**ST. LUCIE PLANT  
UNIT 1 AND UNIT 2**

**IMPROVED TECHNICAL  
SPECIFICATIONS CONVERSION**

**ITS SECTION 3.4 REACTOR  
COOLANT SYSTEM (RCS)**

**Revision 0**

Figure 3.4.3-1  
Reactor Coolant System Pressure versus Temperature Limits -  
Heatup, Criticality, and Inservice Test Limits  
(55 EFPY)

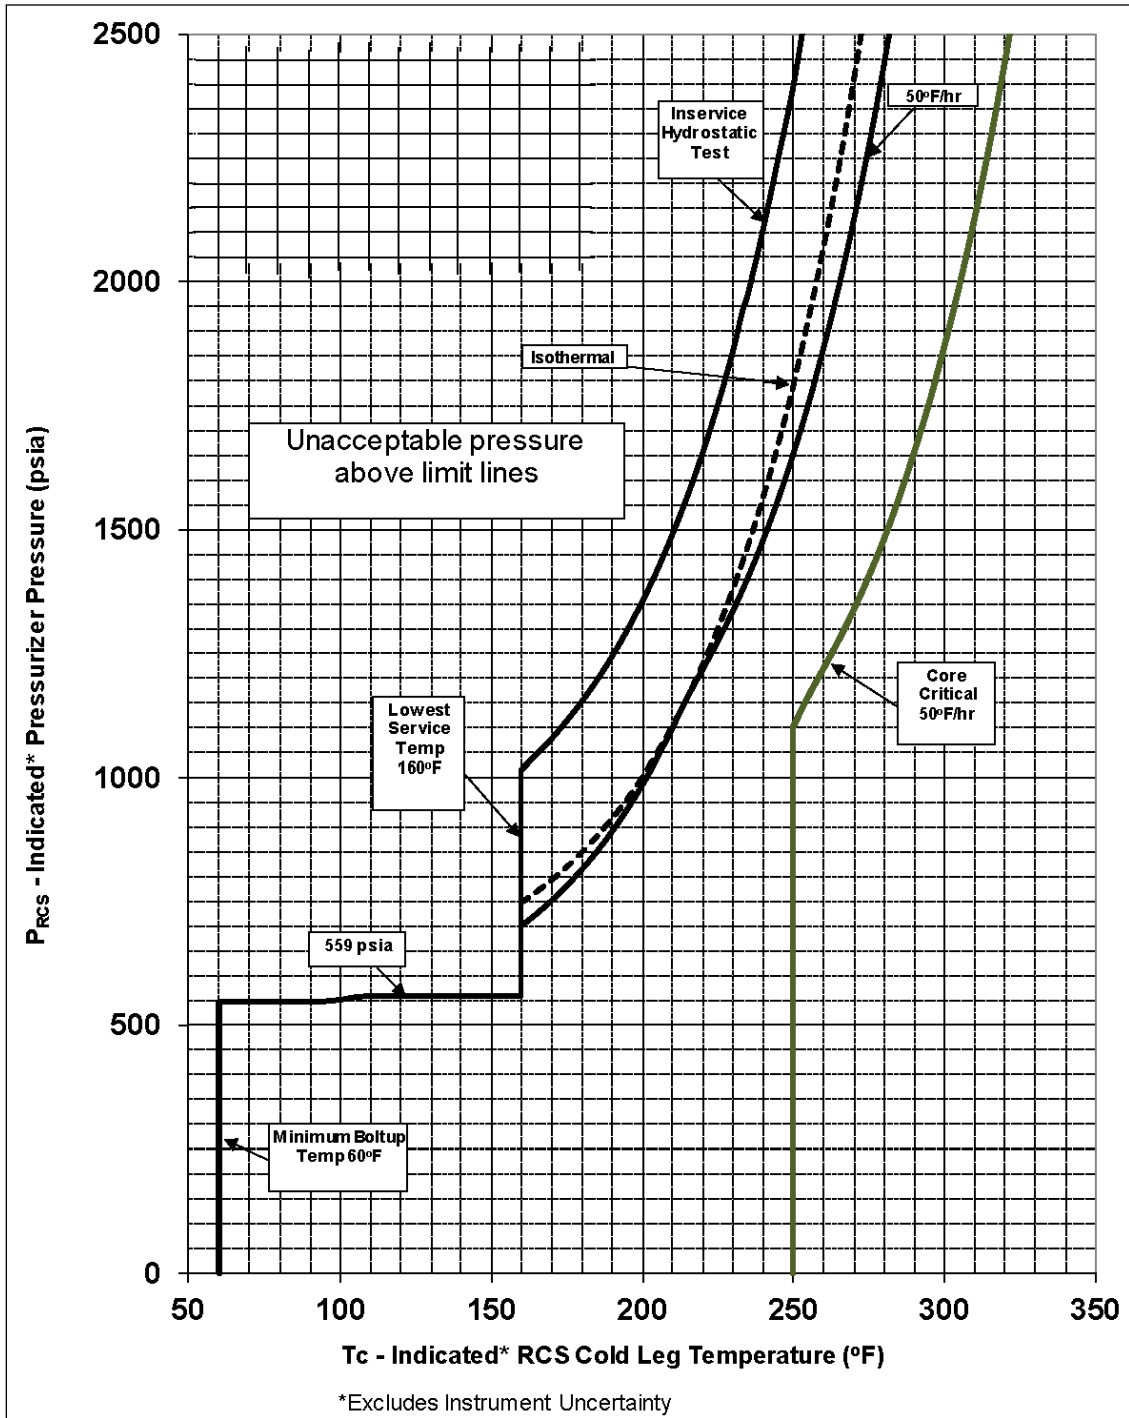
CTS Figure  
3.4-2

3. PSL is not adopting a Pressure Temperature Limits Report (PTLR) and is retaining the RCS Pressure and Temperature (P/T) limits in the ITS. Therefore, references to the PTLR have been changed to Figures 3.4.3-1 and 3.4.3-2. In addition, the CTS P/T figures have been added to ITS 3.4.3 as Figures 3.4.3-1 and 3.4.3-2.

Figure 3.4.3-2  
Reactor Coolant System Pressure versus Temperature Limits -  
Cooldown and Inservice Test Limits  
(55 EFPY)

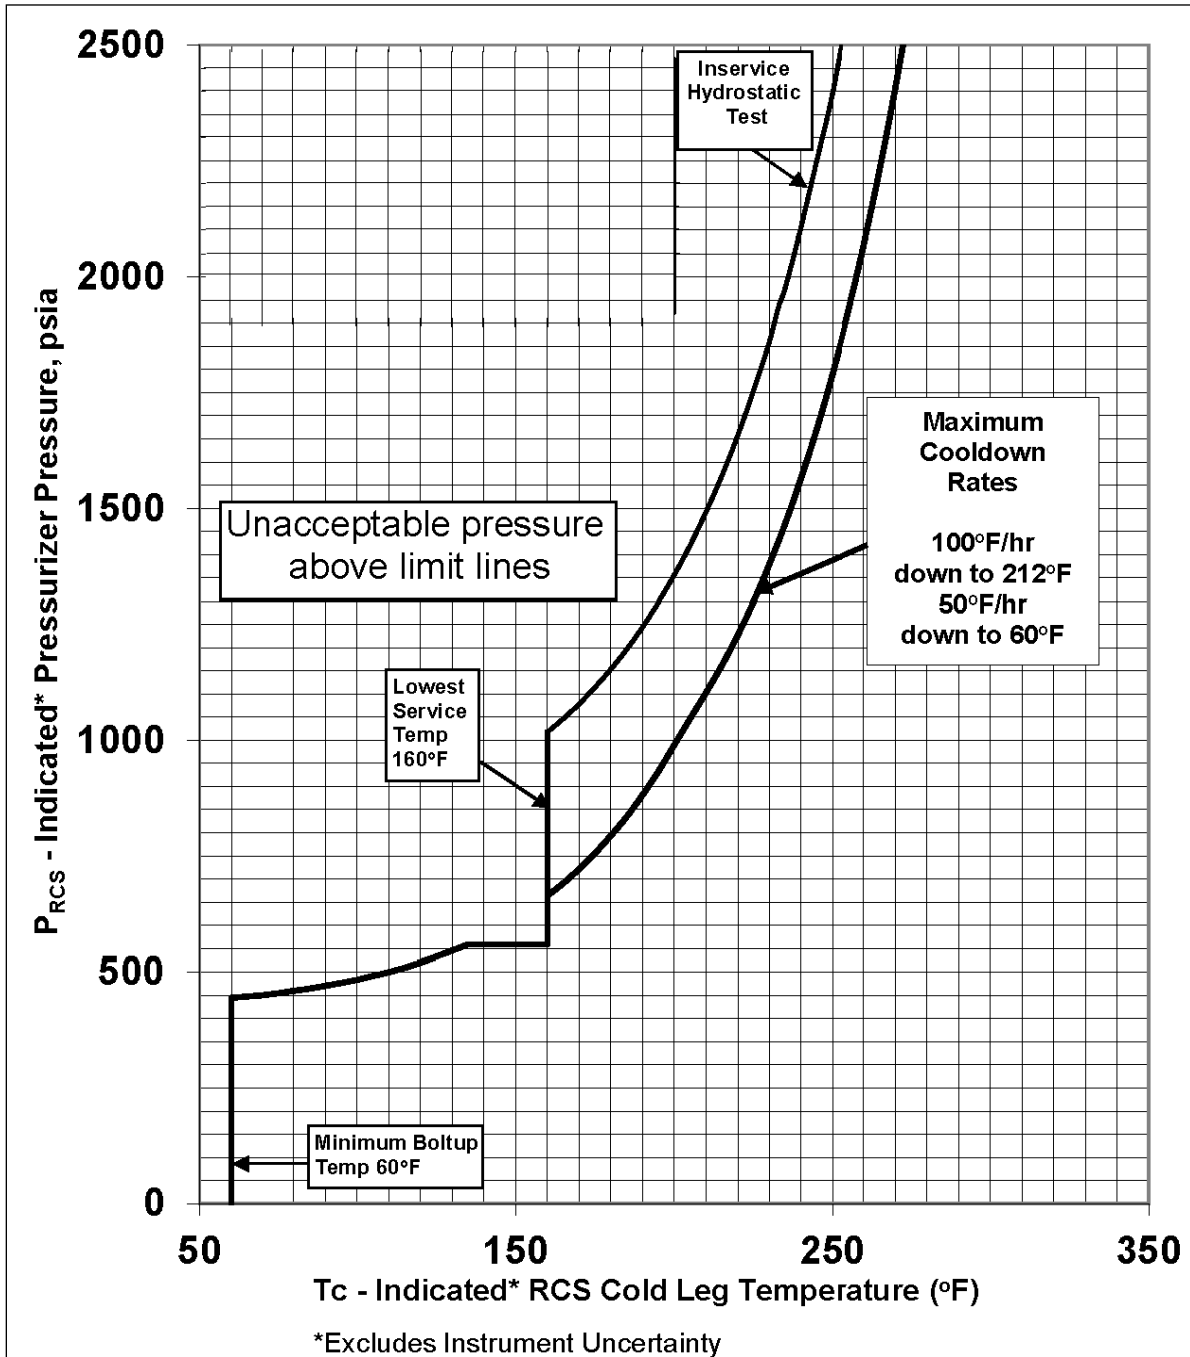
CTS Figure  
3.4-3
